ENGINE - FUEL AND CONTROL - ENGINE - FUEL - INTRODUCE AN IMPROVED FUEL FILTER ELEMENT
- CATEGORY CODE 6 - MOD.ENG-73-0039

V2500-ENG-73-0039

Replacement of the Fuel Filter Element
Fig.1

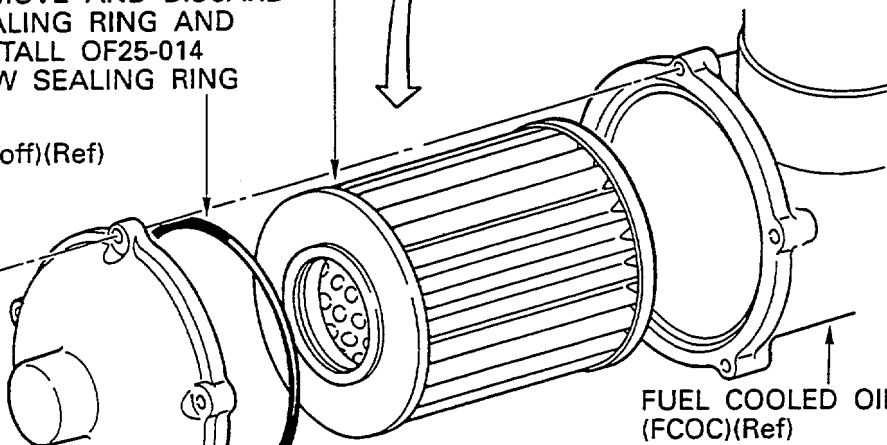
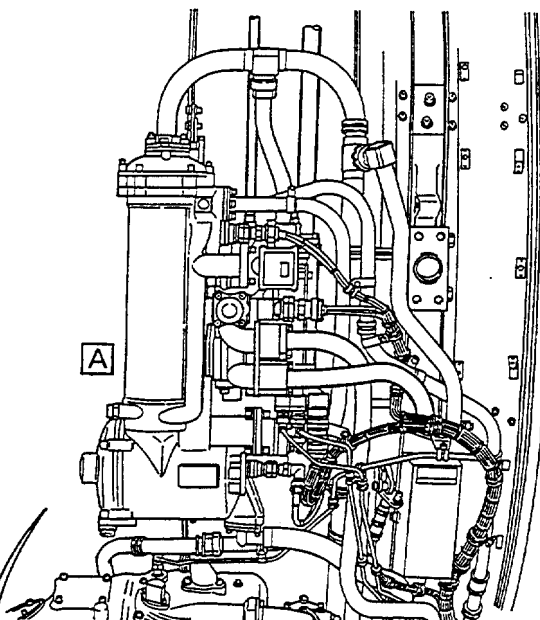
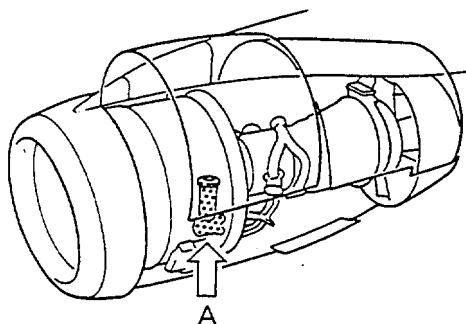
- (1) The new 5L0048, Fuel Filter has been introduced which is added protective layer in the element and increase durability against heavy fuel flow fluctuation.
- (2) To prevent inadvertant incorrect filter assembly and to obtain parts commonality.

REMOVE AND DISCARD 5L0013
FUEL FILTER ELEMENT AND
INSTALL 5L0048 FUEL FILTER ELEMENT

REMOVE AND DISCARD
SEALING RING AND
INSTALL OF25-014
NEW SEALING RING

REMOVE AND INSTALL OF25-005
CAP FILTER ASSEMBLY (1 off)(Ref)

REMOVE AND DISCARD
SEALING RING AND
INSTALL OF25-021
NEW SEALING RING

- (5) Remove and discard the 5L0013, Fuel Filter Element from the FCOC. (See Figure 1.)

- (6) Install the new, 5L0048, Fuel Filter Element into the FCOC. (See Figure 1.)
